P.O.#: V43683
ORDER #: 80868119
MODEL: EPE500

PROPRIETARY NOTICE THIS DRAWING CONTAINS CONFIDENTIAL AND TRADE SECRET INFORMATION. IS THE PROPERTY OF INGERSOLL-RAND CO. AND IS GIVEN TO THE RECEIVER IN CONFIDENCE. THE RECEIVER BY ACCEPTANCE AND RETENTION OF THE DRAWING ACCEPTS THE DRAWING IN CONFIDENCE AND AGREES THAT, EXCEPT AS AUTHORIZED IN WRITING BY INGERSOLL-RAND CO. IT WILL (1) NOT USE THE DRAWING OR ANY COPY THEREOF OR THE CONFIDENTIAL OR TRADE SECRET INFORMATION THEREIN; (2) NOT COPY THE DRAWING; (3) NOT DISCLOSE TO OTHERS EITHER THE DRAWING OR THE CONFIDENTIAL OR TRADE SECRET INFORMATION THEREIN; AND (4) UPON COMPLETION OF THE NEED TO RETAIN THE DRAWING OR UPON DEMAND, RETURN THE DRAWING, ALL COPIES THEREOF, AND ALL MATERIAL COPIED THEREFROM.		TITLE PLAN, FOUNDATION REMOTE COOLED UNIT	
SIZE A1	DWG NO. 24027609	REV A	
SCALE NTS	SHEET 3 OF 3

FRONT VIEW

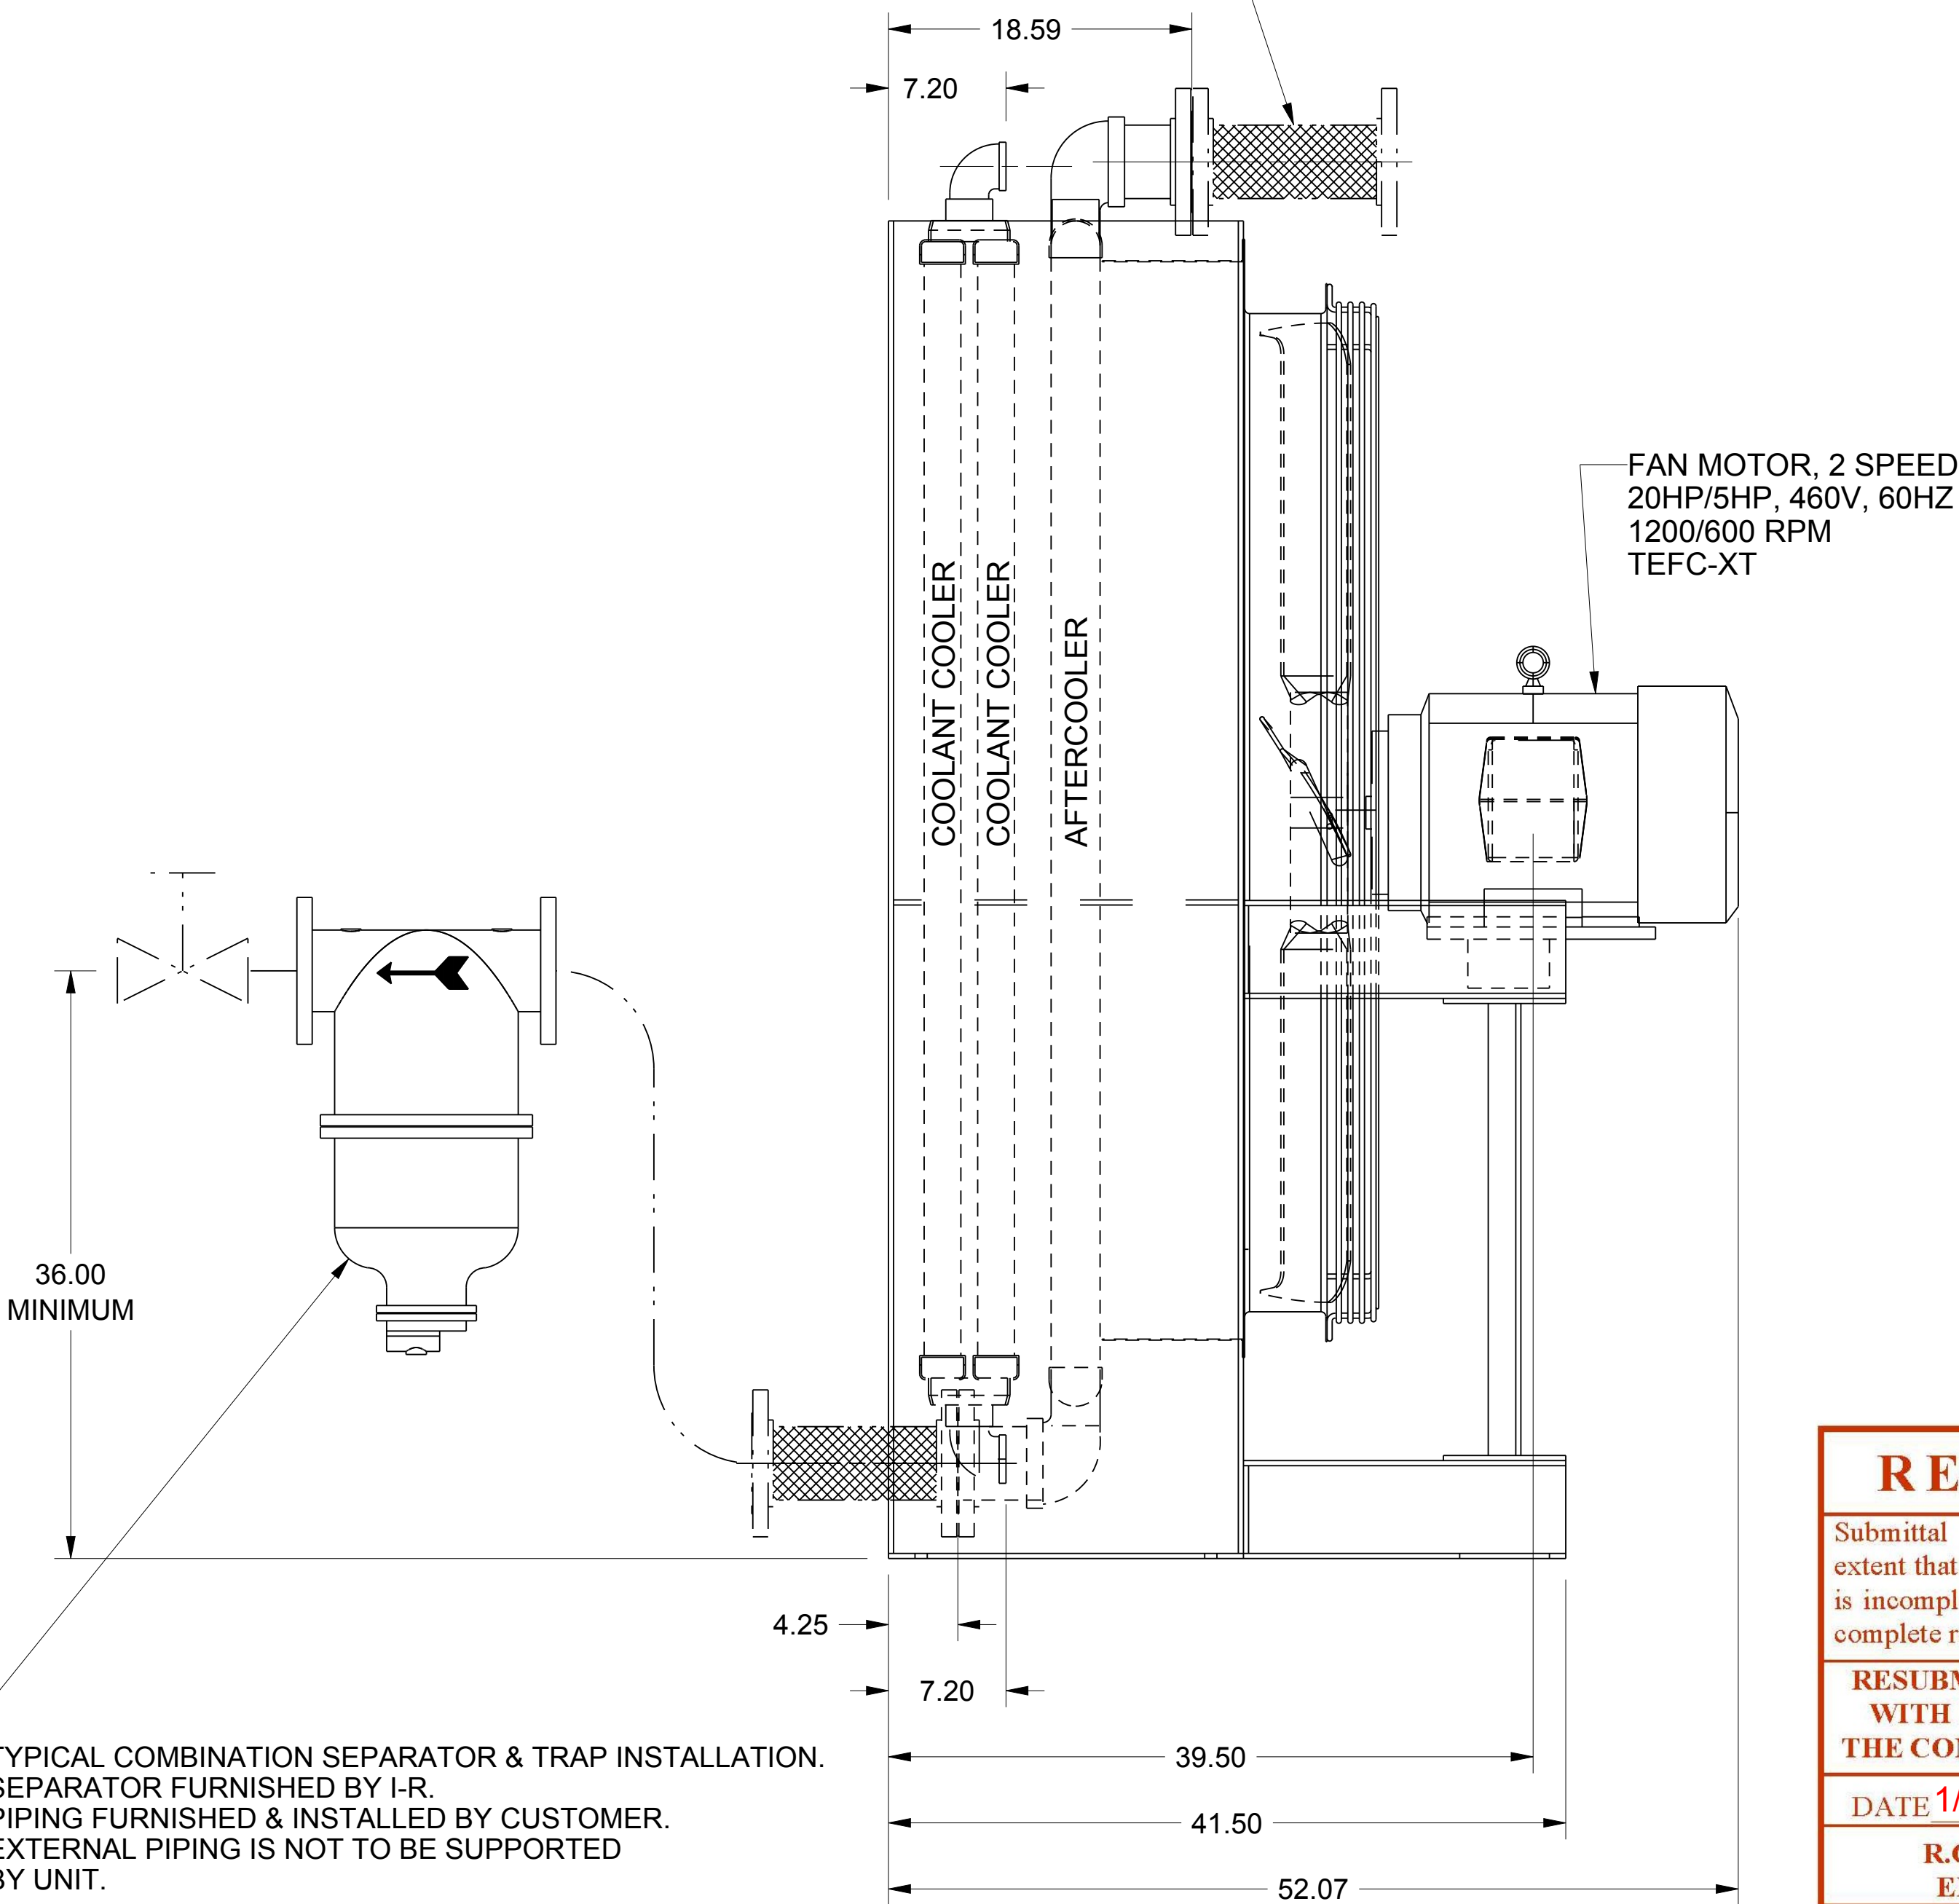
FLEX COUPLING REQUIRED AT
AFTERCOOLER INLET & OUTLET

REJECTED

Submittal is incorrect to such an extent that material is unacceptable or is incomplete to such an extent that a complete review cannot be made.

RESUBMIT IN ACCORDANCE WITH REQUIREMENTS OF THE CONTRACT DOCUMENTS
